**Subject:** Planning Commission Meeting 8\_5\_21 21-RSUB-0007 8000 Dobson Lane

Subject: 8000 Dobson Lane

I am writing to you today requesting that you re-examine the use of Dobson Lane as a connection to proposed development 21-RSUB-0007 (8000 Dobson Lane). To be clear I am asking that the Planning Commission require the use of Dobson Lane for construction and its eventual utilization as a connection to Brentlinger Lane. I have examined this case and listened to the input of residents neighboring this development. This connection would bring many benefits to the area.

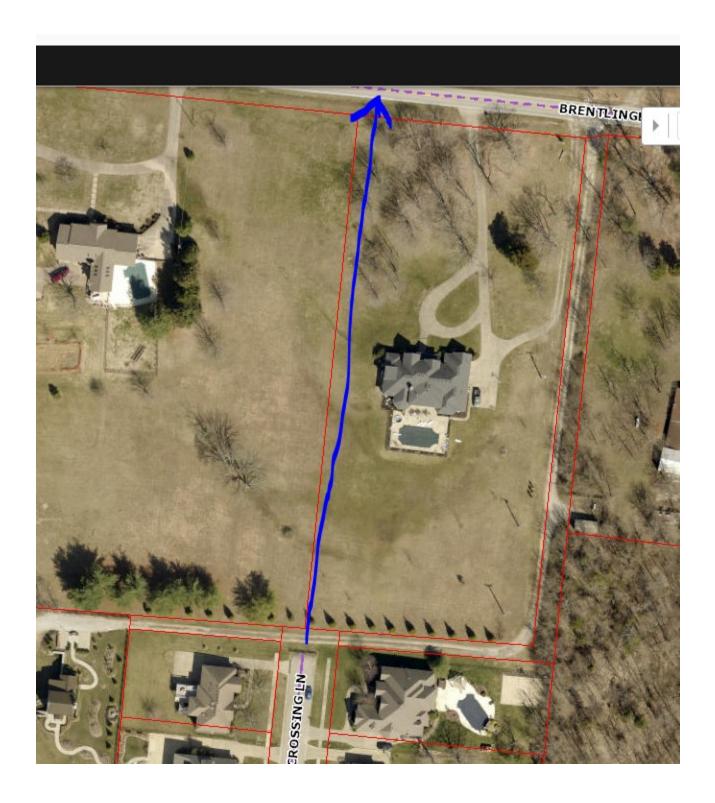
The neighborhood meeting last night with Ball Homes brought up concerns regarding traffic through Glenmary subdivision. Bardstown Road has so much traffic and we should be looking at ways to divert traffic to other roads. The proposed 103 home subdivision going in at 8000 Dobson lane would only add to the traffic. One option would be to spend millions to upgrade Dobson lane and see only half of the 103 homes in proposed subdivisions use it. Or option two, extend Kendrick Crossing drive 600 ft to Brentlinger Road. 250 Glenmary and 103 proposed homes could use this access. Emergency equipment (ambulances and fire trucks) would have quicker access to this area. Plus a lot of people would take Brentlinger over to Billtown road, (less traffic on Bardstown Road) Construction traffic could use this entrance and not tear up Colonel Hancock drive! The property on Brentlinger is currently for sale, where the extended road would go. Maybe Ball Homes or county could buy it and put in road and resale home on property! Do you think this could be a possible option to solve problem?

I am attaching a picture below of the path that I think you are suggesting. I am not sure if this would be a plausible option

as we would need to cross three different properties. All of which are not currently owned by Metro.
